Work Order ID 88092

Item ID: D407-667-105

Item Name: Crosstube Fwd

DRAWING NO. D407-667-145	TITLE CROSSTUBE ASS'Y (407 HIGH FWD)	REV. C	DART AEROSPACE LTD ENGINEERING ORDER		D.E.O. NO. D407-667-145-C-1	SHEET NO. SHEET 1 OF 1	SCALE NTS
DRAWN <i>47</i>	CHECKED <i>ASS</i>	MFG. APPR. <i>18</i>	APPROVED <i>WD</i>		DE APPR. <i>11</i>		
DATE 11.07.15	DATE 11.07.22	DATE 11.07.22	DATE 11/07/22		DATE 11.07.21

D407-667-145
ASSEMBLY DETAIL
(VIEW LOOKING FWD)

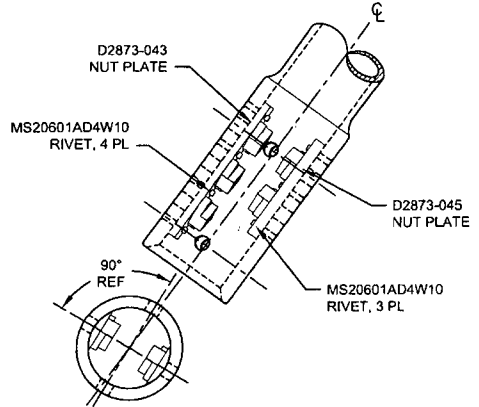
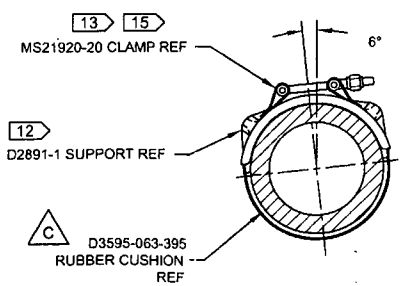
REPLACE MAGNOBOND WITH PROSEAL.

NOTE 12 & 15, SHEET 1 IS AMENDED AS FOLLOWS:

- 12) TO INSTALL D2891-1 SUPPORT: ABRASE MATING SURFACE OF SUPPORT AND CROSSTUBE WITH 180-GRIT SANDPAPER AND REMOVE RESIDUE WITH MEK (OR EQUIVALENT). APPLY A 0.04" TO 0.07" THICK LAYER OF PROSEAL 890 CLASS B-2 (OR AMS-S-8802 CLASS B-2) SEALANT TO MATING SURFACE OF SUPPORT.
- 15) TORQUE CLAMPS 80 TO 100 IN-LB. ENSURE AT LEAST 1.5 THREADS SHOWING IN SAFETY AND THAT NUT HAS NOT BOTTOMED-OUT AFTER TORQUING. **PRIOR TO PACKAGING, RE-CHECK TORQUE ON CLAMPS AFTER PROSEAL 890 SEALANT HAS CURED FOR 72 HOURS.**
